Agenda Bill 2023-03-13-03

Subject: Appeal of WAP-22-02

To hold a public hearing and consider the appeal (AP-23-01) by Russell Axelrod of the Planning Manager's approval of application WAP-22-02, a Water Resource Area Permit at 19679 Wildwood Drive.

REQUEST: Appeal of the Planning Manager decision to approve a Water Resource Area (WRA) Alternate Review to reduce the existing WRA buffer and increase the buildable area for future construction at 19679 Wildwood Drive

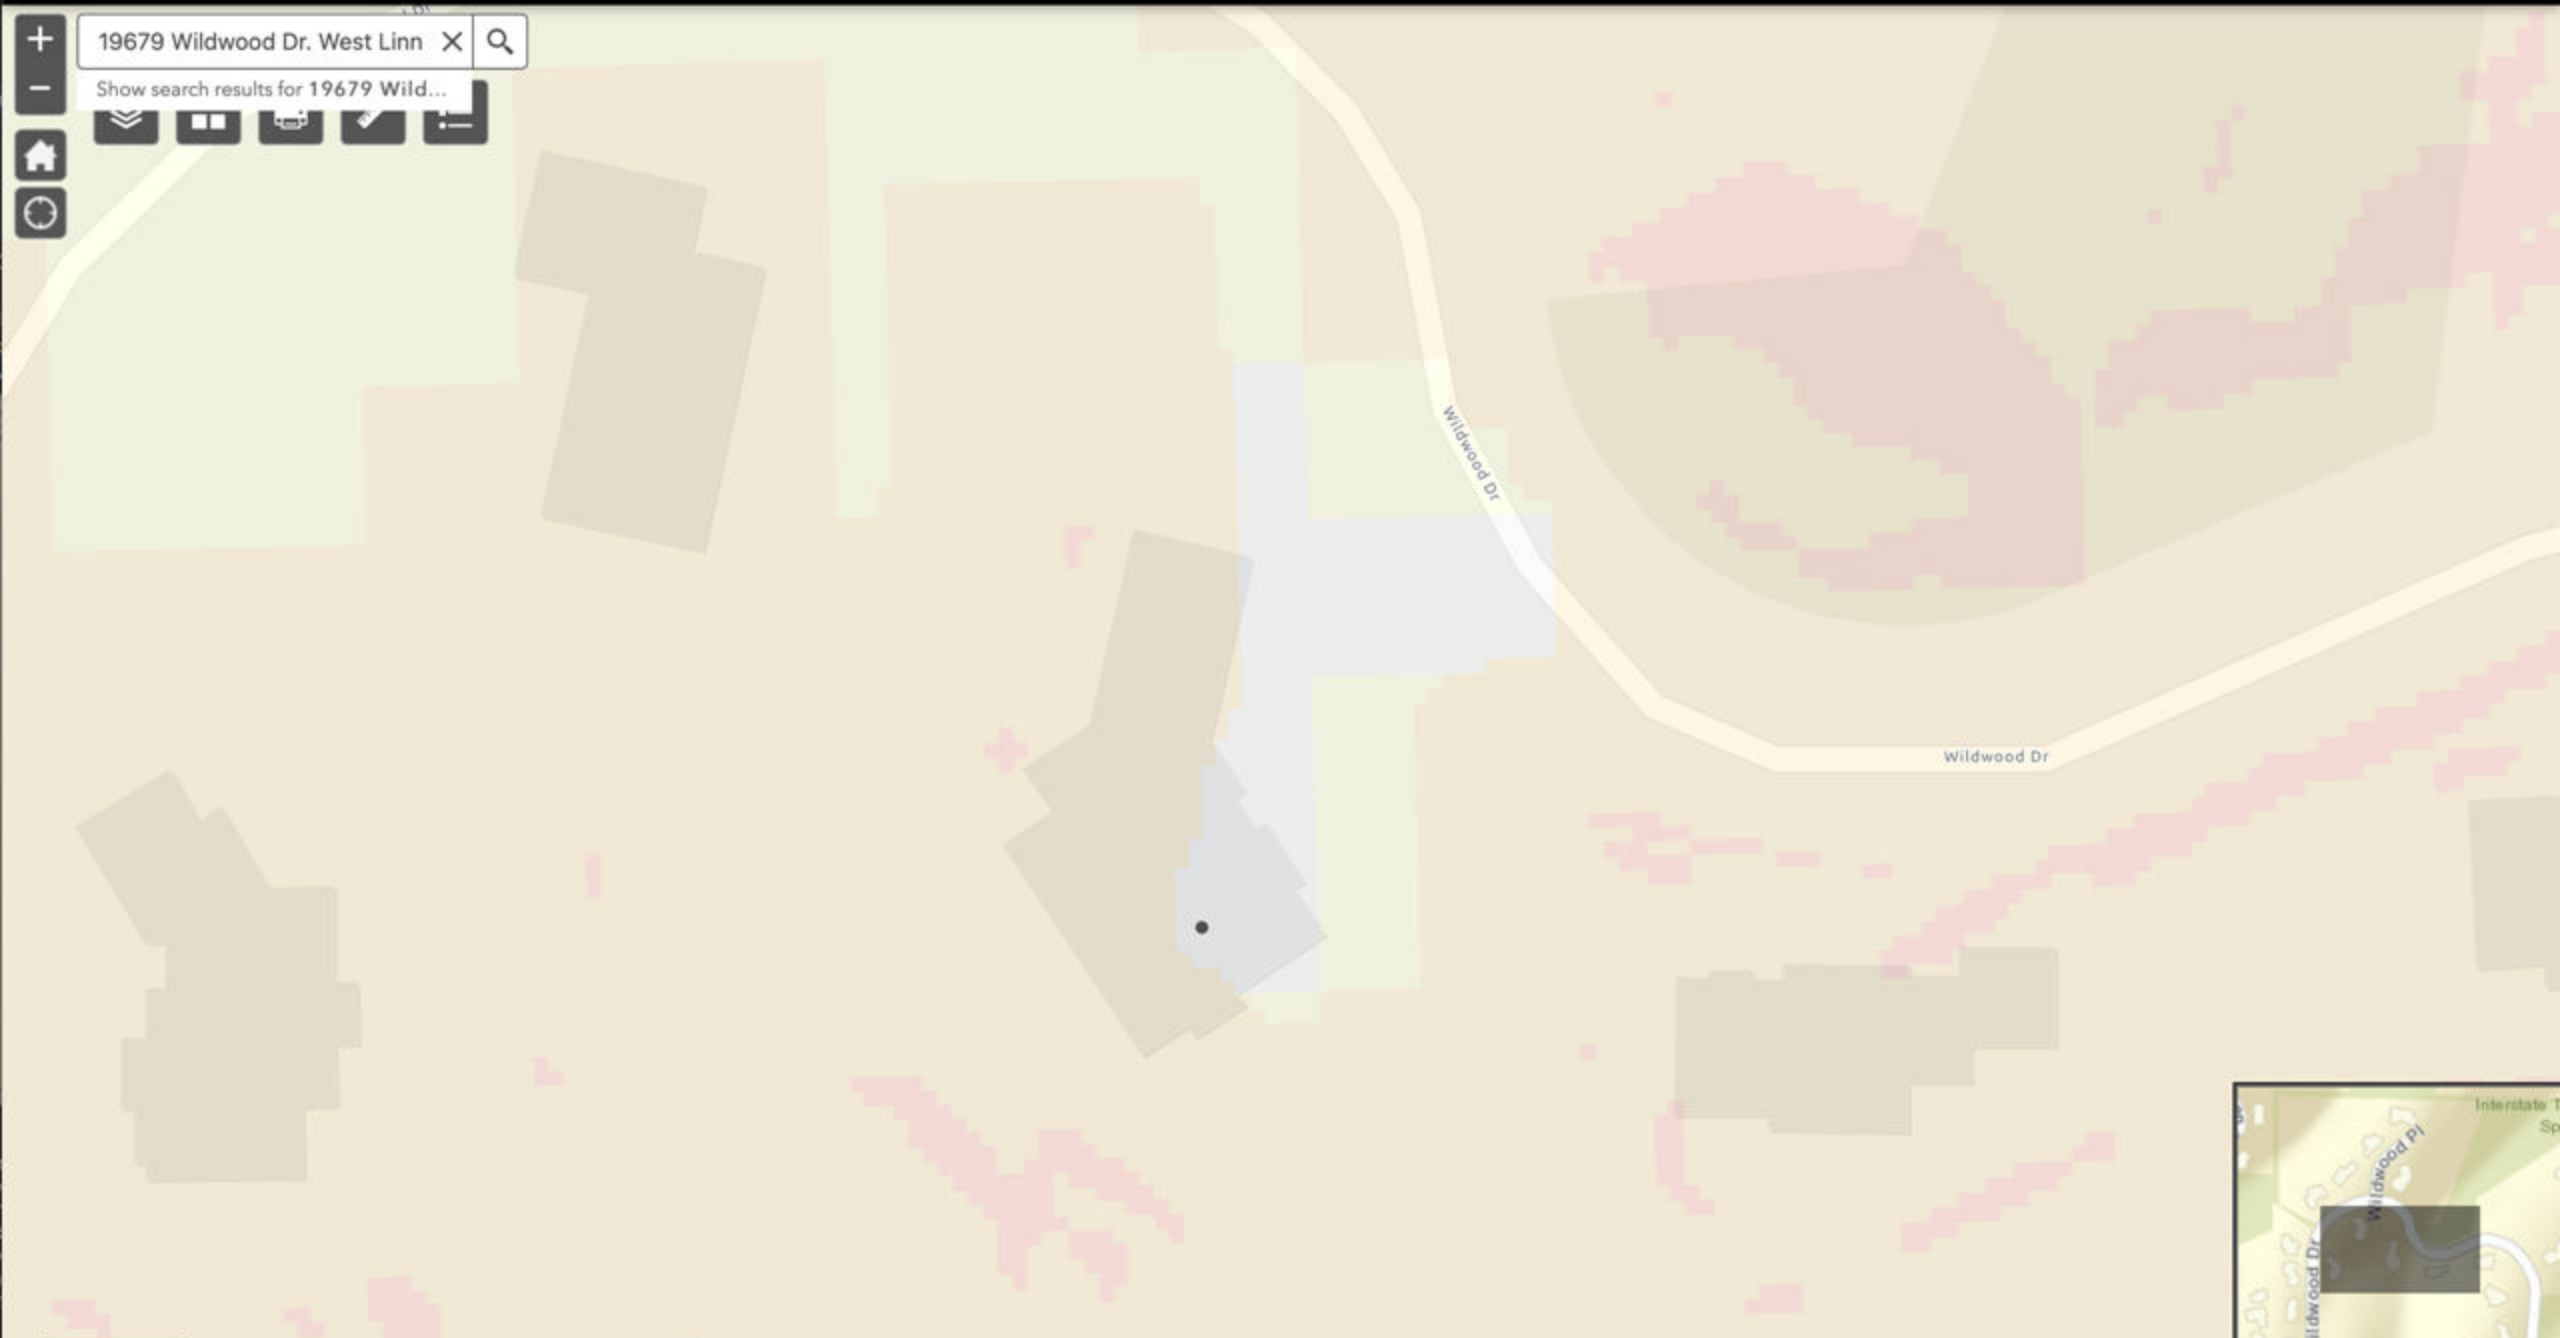
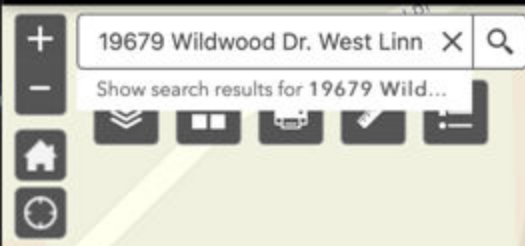
Looking at CDC 32.030 (Prohibited Uses) Table 32-1 I do not see the exact situation for this application but I find some parts interesting and related.

1. New House principal structure is not permitted except by hardship CDC 32.100. Geotechnical study may reduce the WRA width. I do not believe this is a hardship situation.
2. New accessory structure under 120 sq. ft. and 10 ft. tall is permitted only if a minimum of 50' from the water resource. The application clearly shows the new structure (which would be much larger than this) would be 15' away from the water at its closest point. Why would it be less strict for this application?
